# GRANDVIEW RESERVE PHASE 2 PUD DEVELOPMENT PLAN & PRELIMINARY PLAN

# V3\_PUDSP.pdf Markup Summary

SHEET  
SP  
08

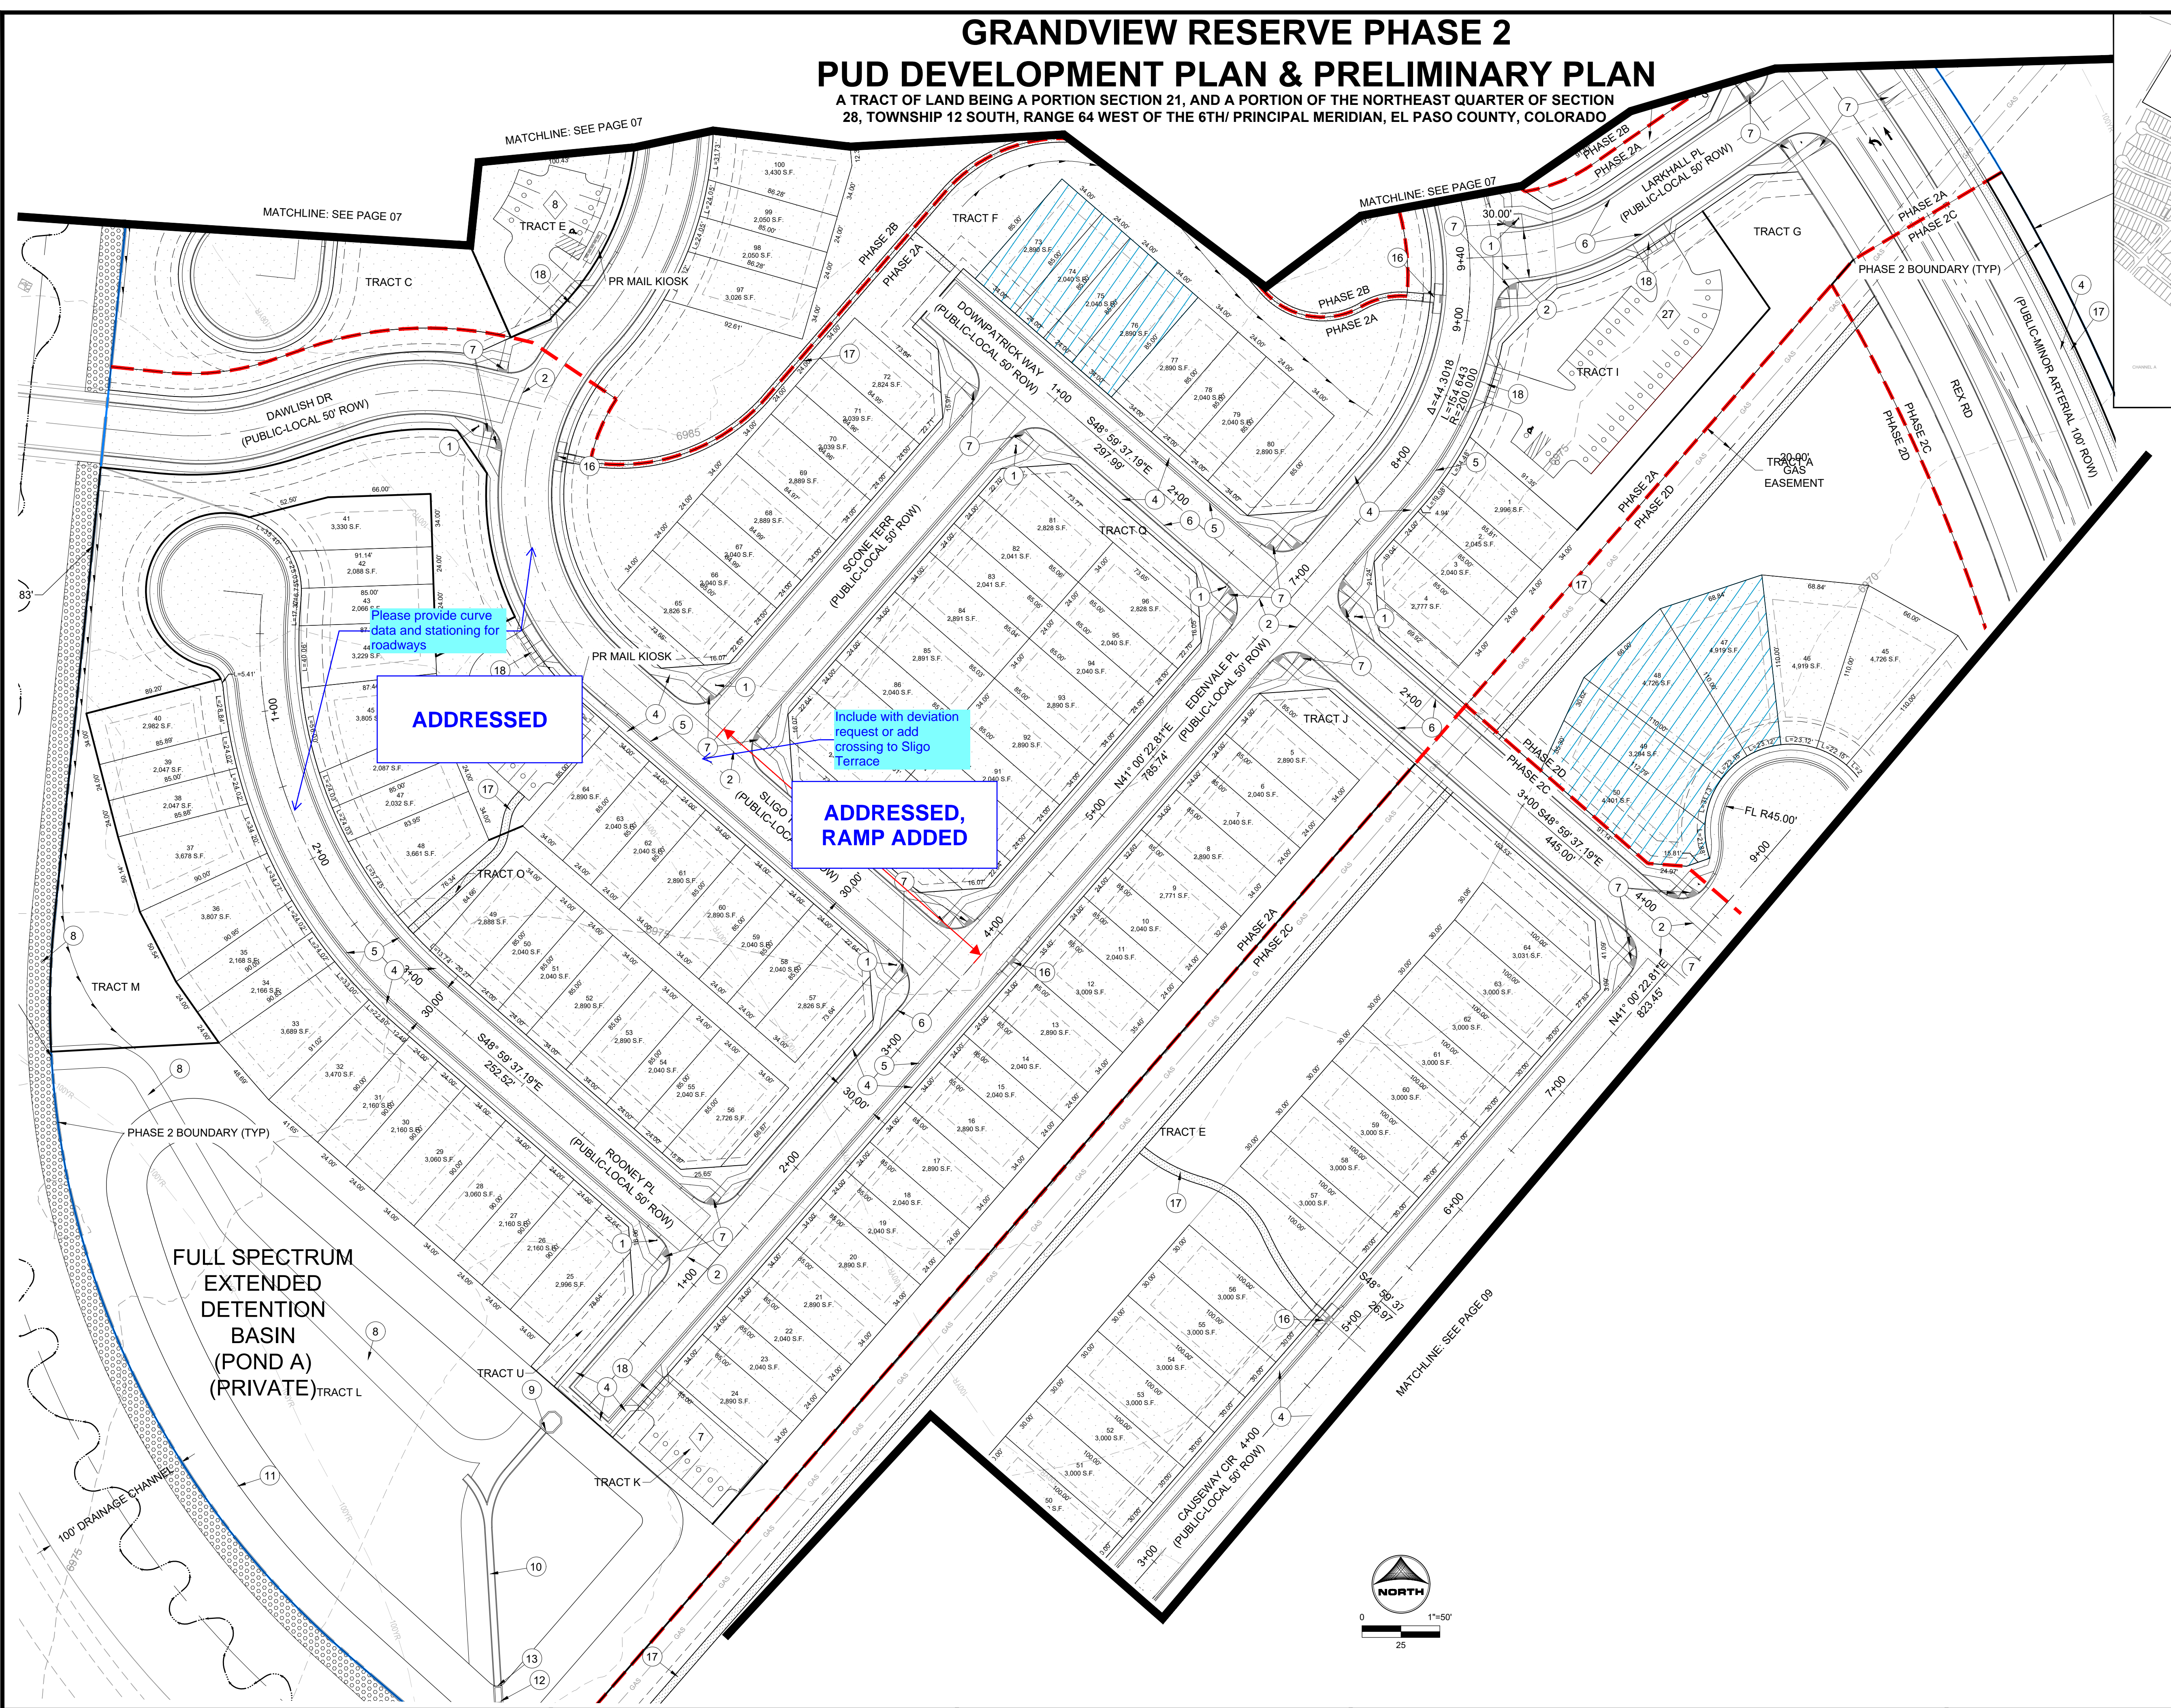
Addressed  
Please provide curve data and stationing for roadways

Addressed, Ramp Added  
Include with deviation request or add crossing to Silgo Terrace

SHEET  
L.03  
16

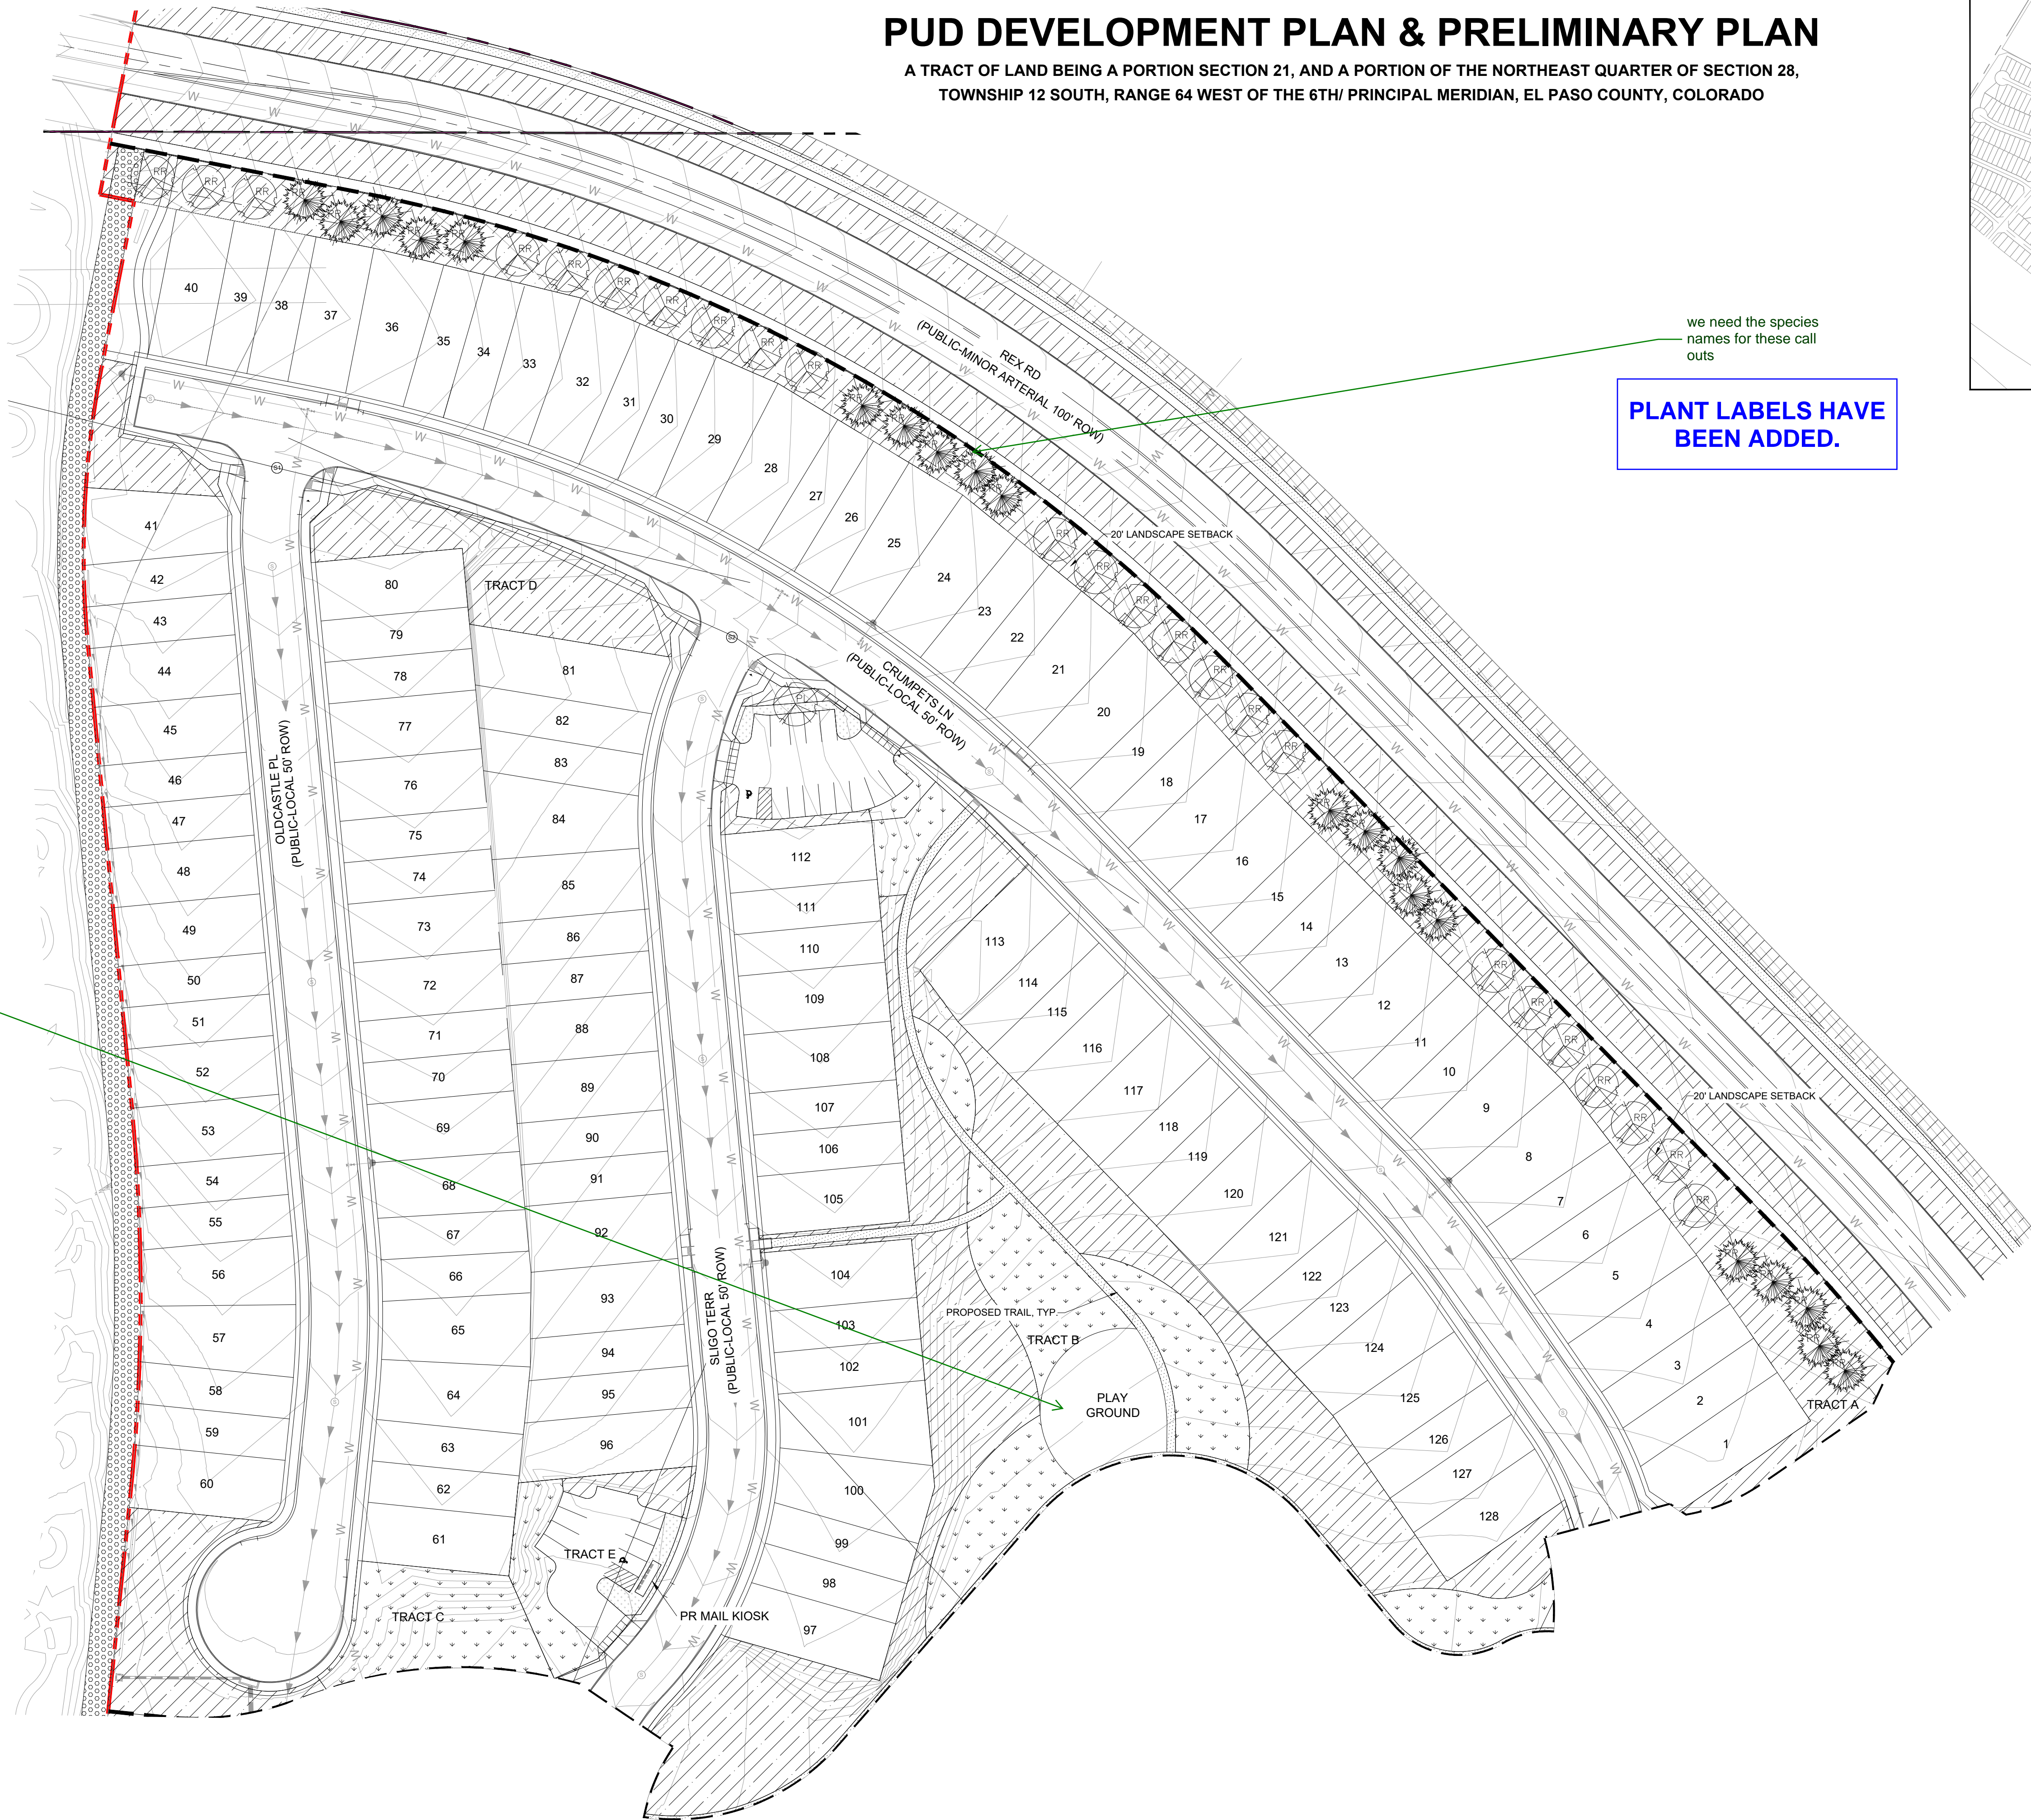
we need the species names for these call outs

**PLANT LABELS HAVE BEEN ADDED.**
